HEWLAND ENG LTD.
 DG300 ILLUS. N° C48

SCALE	F.SIZE.	LIMITS	+ $\frac{1}{64}$ IN. UNLESS OTHERWISE SPECIFIED	DATE
				11-9-72
FINISH	-			
DRAWN BY	MATERIAL	SPEC.	COND.	REMARKS
EJ				
ISSUE				
1				
DATE				
11-9-72				
DETAILS		TITLE		
NEW DRAWING		MODIFIED CLUTCH SPIGOT & BEARING CARRIER.		
SHEET OF		PART NO.		
		P8-Q-427.

C49.

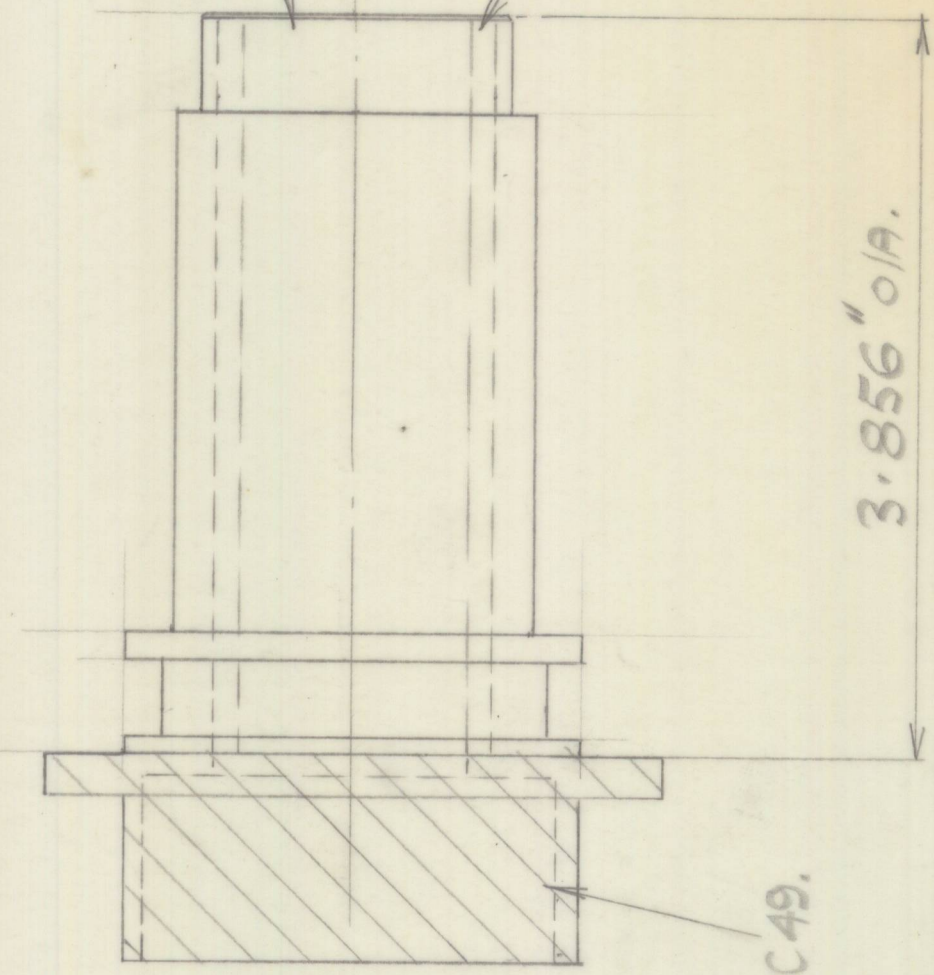
REDUCE TUBE ON SPIGOT (C49)
 TO SUIT MODIFIED BEARING
 CARRIER.

3.856" o/a.
